Subject: Request for Focused Site Conceptual Model Addendum and Data Gap Work Plan; Fuel Leak Case No. RO0000274 and Geotracker Global ID T0600102079, Chevron #9-3322; 7225 Bancroft Avenue, Oakland, CA 94605

Therefore, at this juncture ACEH requests that you prepare a Revised Data Gap Investigation Work Plan that is supported by a focused Site Conceptual Model (SCM) to address the Technical Comments provided below.

SITE AND PIPING PLAN

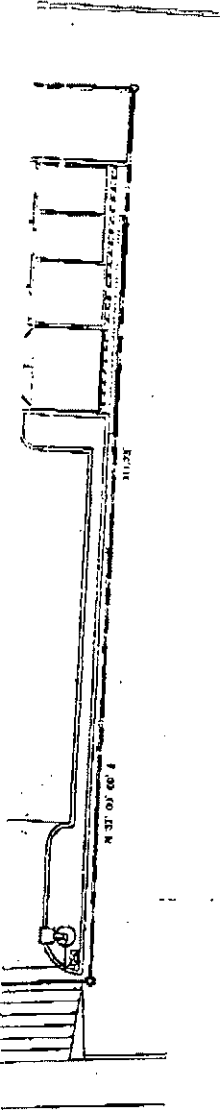
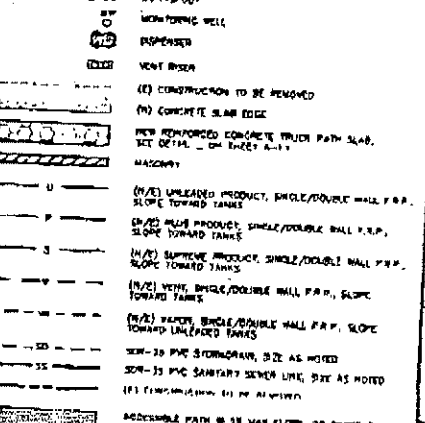
Additionally, ACEH’s files contain a facsimile copy (dated August 14, 1996) of a former site schematic that indicates that a piping “elbow sloughed off” near the southern dispensers associated with an earlier tank configuration, and that no soil sample had been collected. Two fuel releases have been

reported to be associated with the site, an earlier leaded gasoline and a reformulated gasoline containing MTBE. ACEH assumes the earlier release may be associated with this release location. This release vicinity has not been further characterized at depth. ACEH has attached a copy of the facsimile. Finally, the presence of elevated ethanol limits of detection in wells MW-1 and MW-7 indicates that a third release has occurred at the site.

Please present a strategy in the Data Gap Work Plan (described in Item 6 below) to address the items discussed above. Alternatively, please provide justification of why the site satisfies this general criterion in the focused SCM described in Item 6 below.
